Drinking Water Audit Report

County:	Donegal	Date of Audit:	19 August 2014
Plant(s) visited:	Bundoran Urban (L. Melvin) Water Treatment Plant	Date of issue of Audit Report:	02 September 2014
		File Reference:	DW2014/303
		Auditors:	Ms Derval Devaney
Audit Criteria:	<ul style="list-style-type: none"> • The <i>European Union (Drinking Water) Regulations 2014 (S.I. 122 of 2014)</i>. • The <i>EPA Handbook on the Implementation of the Regulations for Water Services Authorities for Public Water Supplies (ISBN: 978-1-84095-349-7)</i> • The recommendations specified in the EPA Report on <i>The Provision and Quality of Drinking Water in Ireland</i>. • The recommendations in any previous audit reports.

Photo 4 Even distribution of backwash water on Filter No. 3

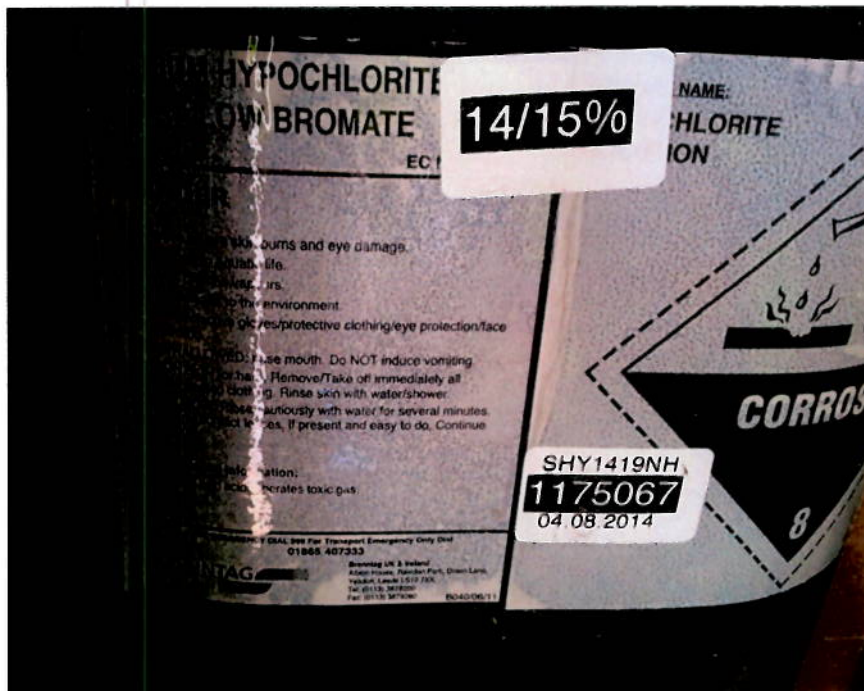
3.	<p>Filtration</p> <ul style="list-style-type: none"> a. Clarified water flows into one of 3 No. Rapid Gravity Filters with a surface area of 12 m² each and a filtration rate of 5.9- m³/m²/hr. b. The filters were upgraded 9 or 10 years ago with filter media replenished to a depth of 1.5m. Currently there is 1.1 m in Filter 1 & 3 and 1.2 m in Filter 2. c. Backwash was observed on Filter No 3 (see Photo 4). Air and water is injected for 5 minutes and then water only until the water runs clear (on average the water wash takes 20 minutes) at a backwash rate of 12.5 m³/m²/hr. The process can be set up to backwash automatically but manual backwash is carried out every 72 hours and is observed by the caretaker. d. Backwash water is diverted to the intake chamber on-site and recycled through the plant. The average raw water flow, including recycled water, through treatment is 215 m³/hr (includes 170 m³/hr is abstracted from source). e. There is a turbidity meter on each filter and a flow meter on the filtered and backwash waters. The turbidity meter during the audit read 0.06 NTU for Filters 1 and 2 and 0.11 NTU for Filter 3. The final water turbidity was 0.05 NTU. f. There is no run to waste, slow or delayed start on the filters once backwash is complete.

2. The Water Services Authority should follow the guidance as specified in the EPA publication “*Water Treatment Manual on Filtration*” and in particular the following action is required as a priority;
 - i. As the filter backwash water is returned to the head of the works ensure that, following backwashing, the filters are run to waste for an appropriate period of time or that there is a slow or delayed start when/prior to the filter being brought back into use.
